URBAN DRAINAGE AND FLOOD CONTROL DISTRICT

UDFCD Maintenance Eligibility Program Referral Review Comments

Project: **Trails at Crowfoot Filing No. 1**
Stream: **Lemon Gulch**
UDFCD MEP Phase: **Design**
UD MEP ID: **106481**

Detention Basin Outlet Structure Design

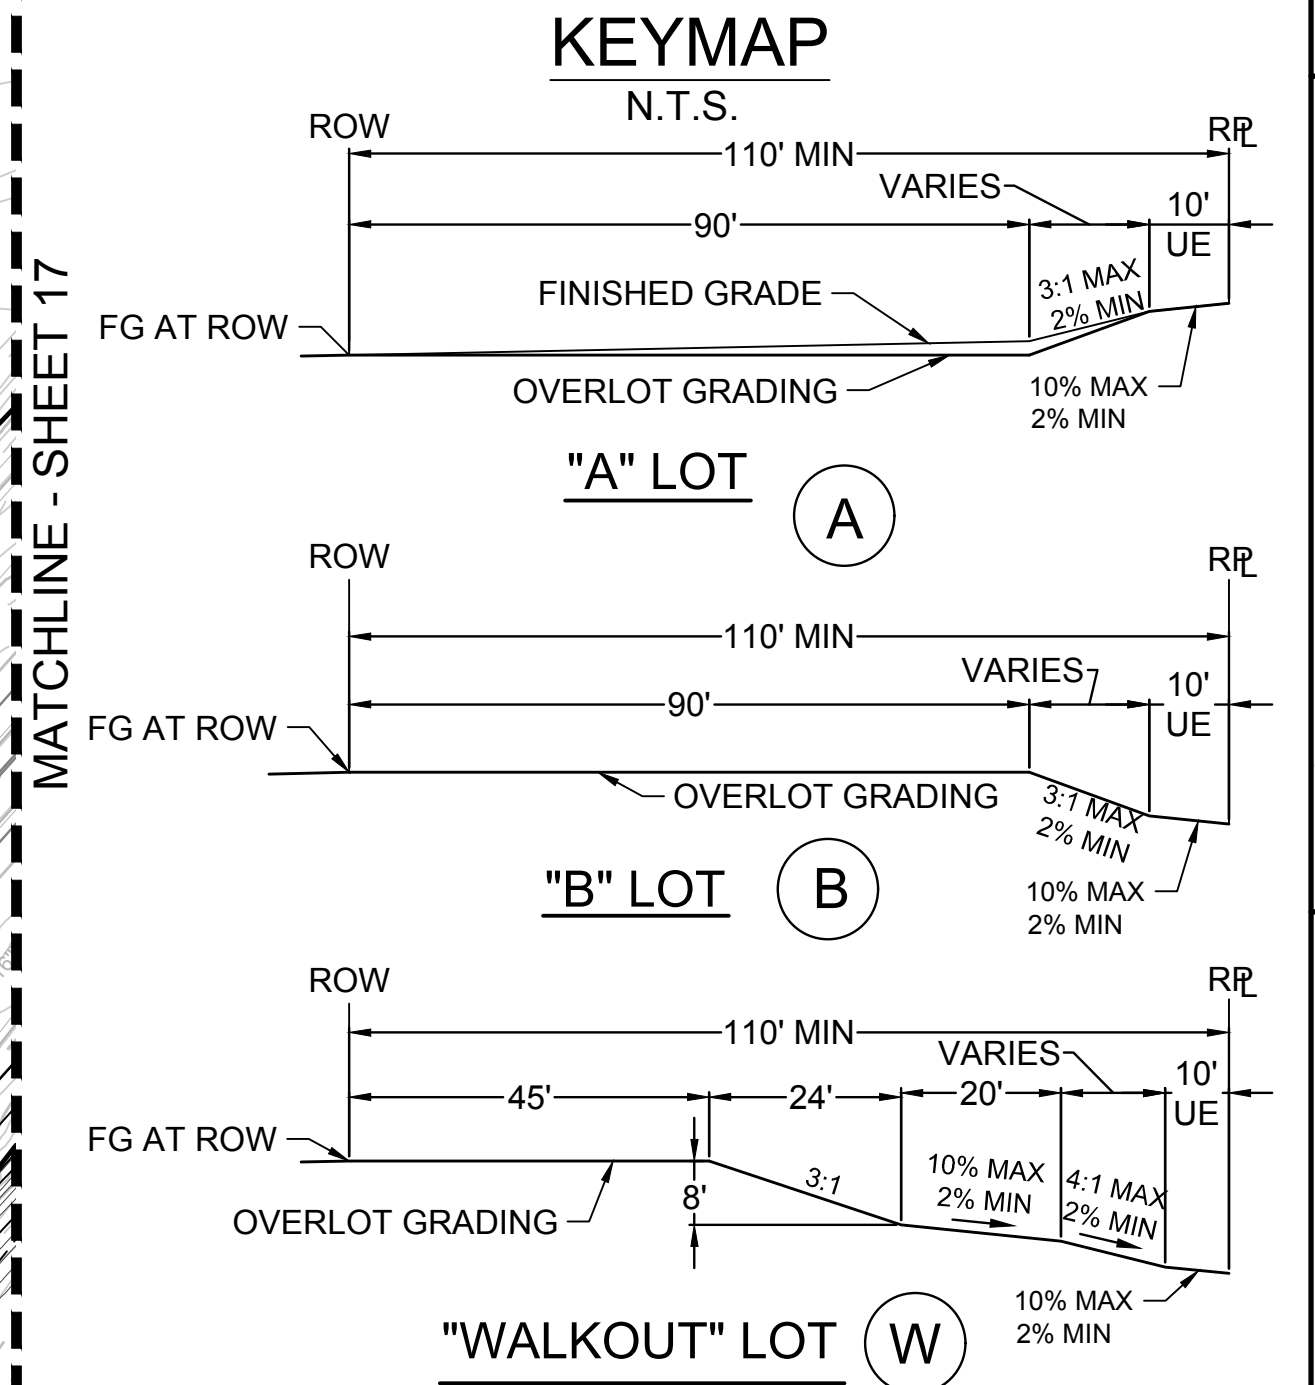
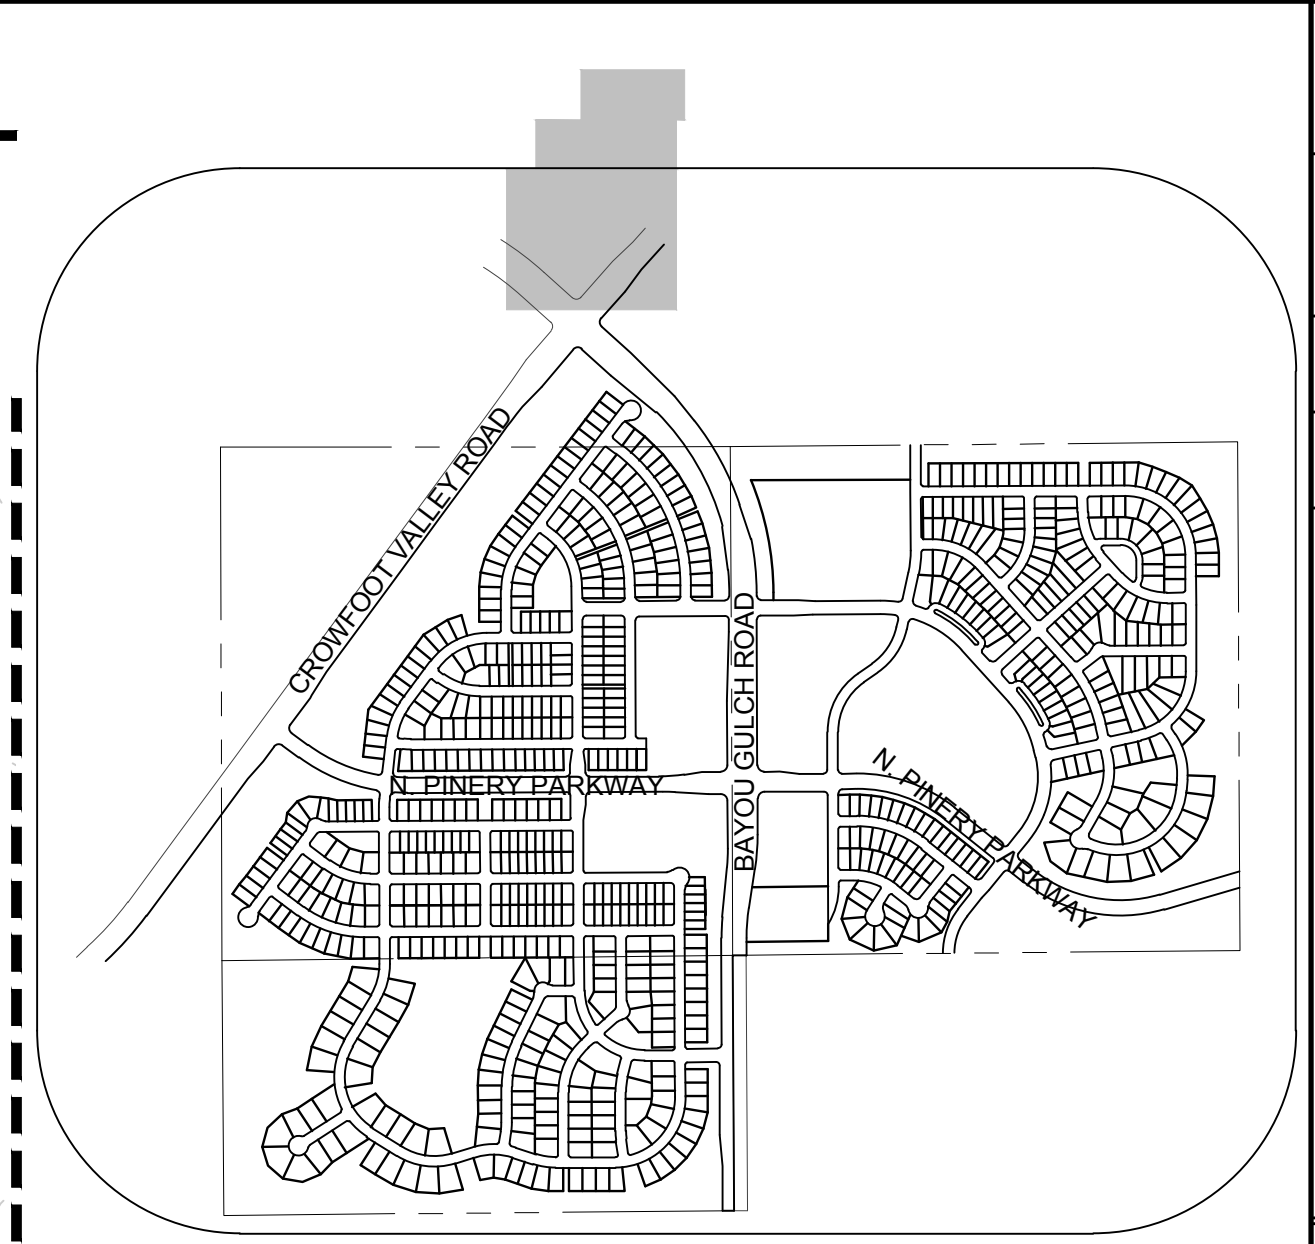
The 5-year design appear to be a bit off. Please check.

FILE NO: 8130283701	FILE NO: 8130283701	FILE NO: 8130283701	FILE NO: 8130283701
SHEET NUMBER 4	SHEET NUMBER 4	SHEET NUMBER 4	SHEET NUMBER 4

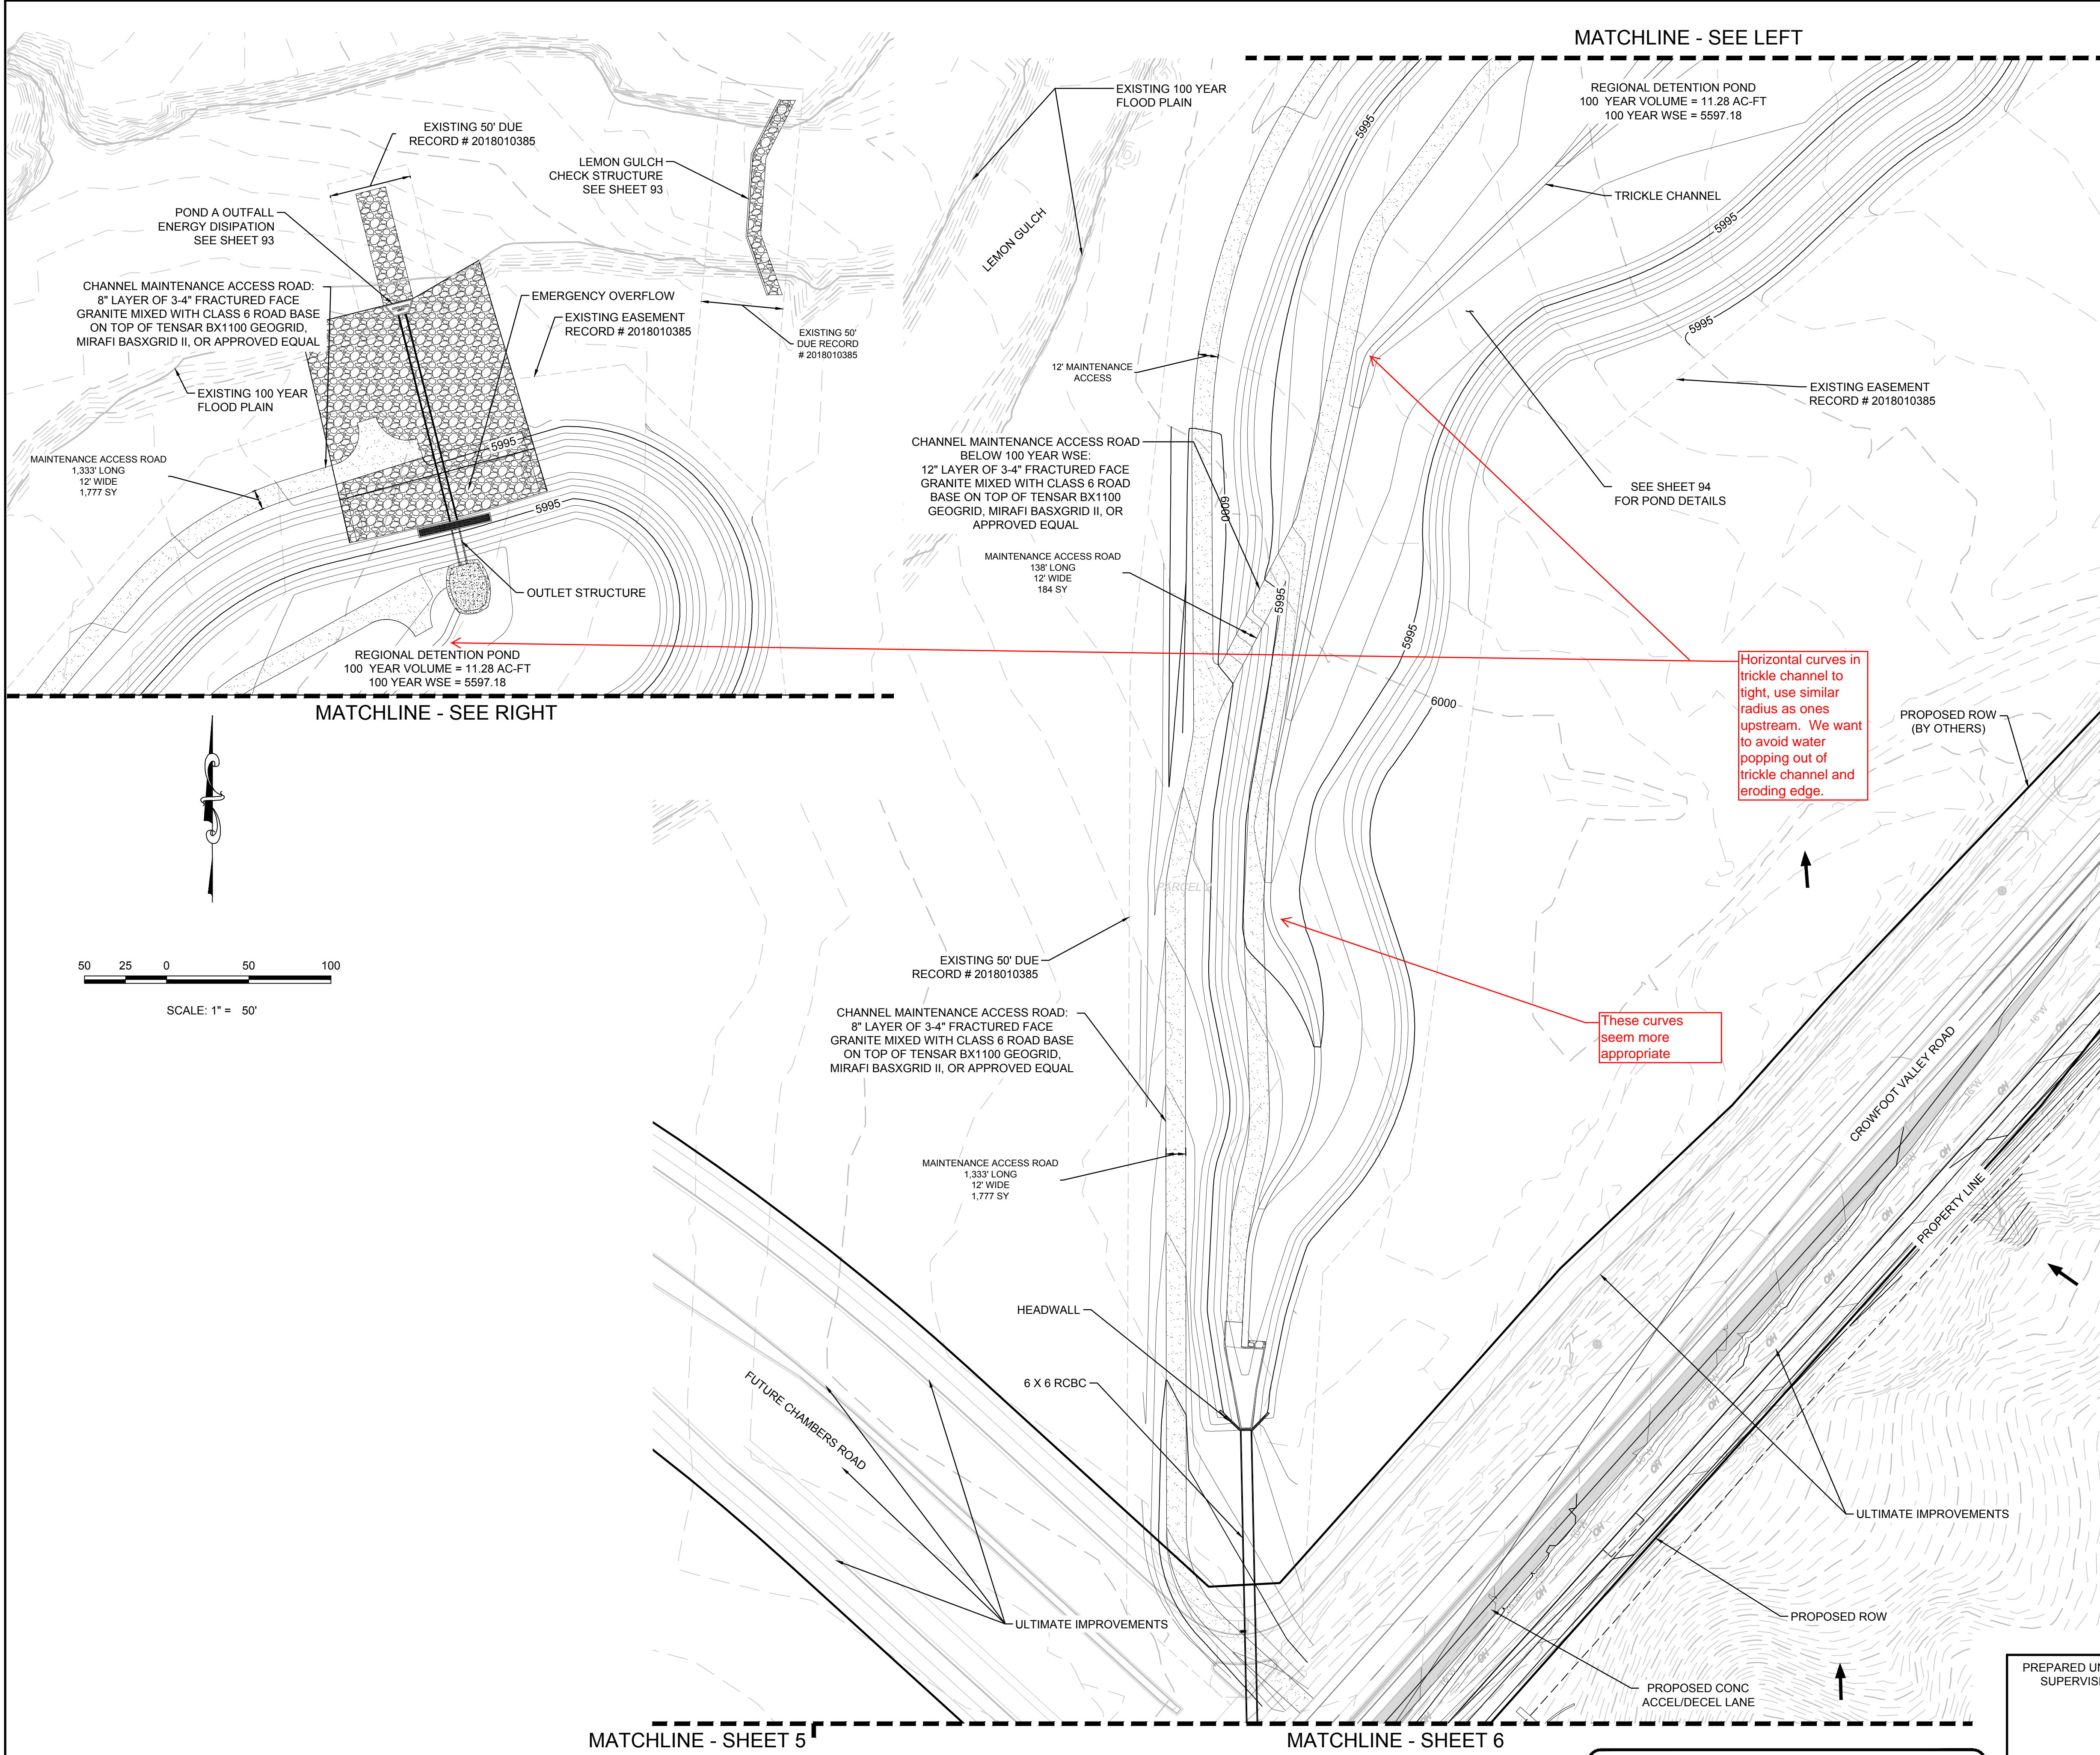
Horizontal curves in trickle channel to right, use similar radius as ones upstream. We want to avoid water popping out of trickle channel and eroding edge.
